**Written submission from the
Radiation Safety Institute of Canada**

Application for the renewal of the nuclear
research and test establishment
decommissioning licence for the Whiteshell
Laboratories site

Review of the CNSC Licence Renewal Application from Canadian Nuclear Laboratories for its Nuclear Research and Test Establishment Decommissioning Licence for Whiteshell Laboratories

Report Date: 12 September 2024

Figure 1 CNSC reportable events by year at the Whiteshell site.

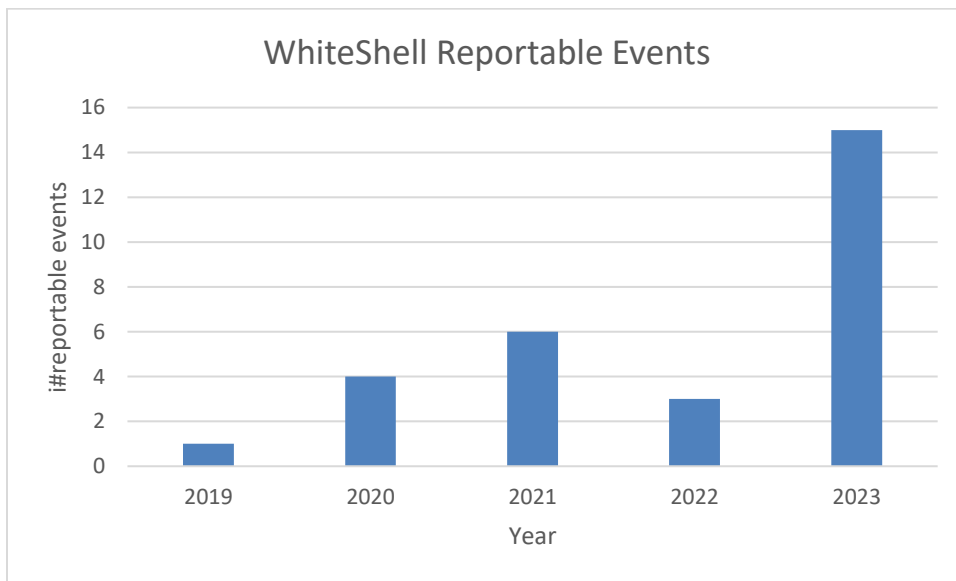
Although a number of the 2023 events, and potentially the majority of them, appear to have been self-identified by CNL, the fact that 2023 had more than four times more reportable events than the average number over the previous 4 years is concerning.

Figure 2 Maximum effective dose to workers.

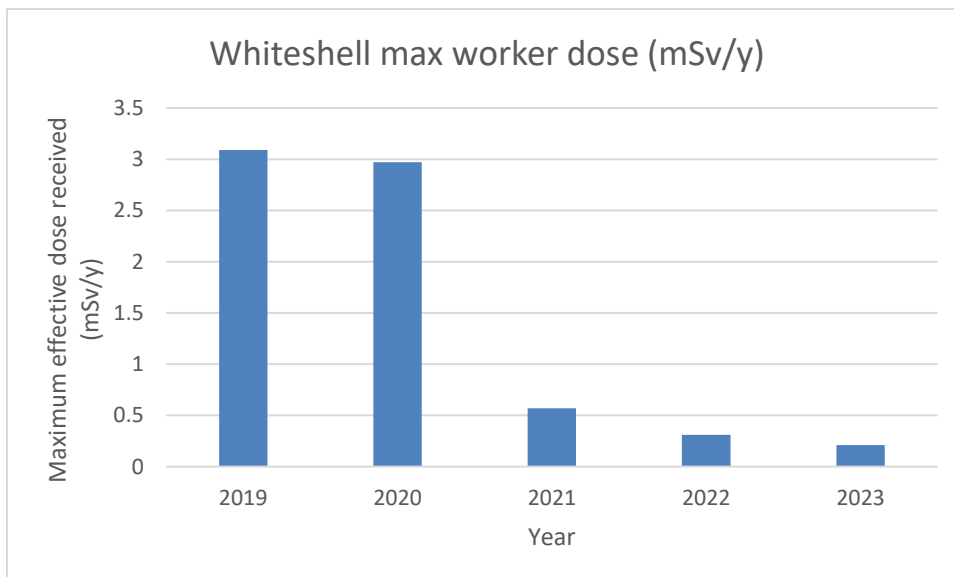
Maximum effected doses to workers have been well below regulatory limits and has trended downwards (note that the safety pause would have reduced worker dose in 2023). The average dose to workers for these years is much less, ranging from 0.1 mSv/y in 2019 to 0.02 mSv in 2023.

Data such as the above suggest that the RP program has been effective at maintaining low doses to workers.
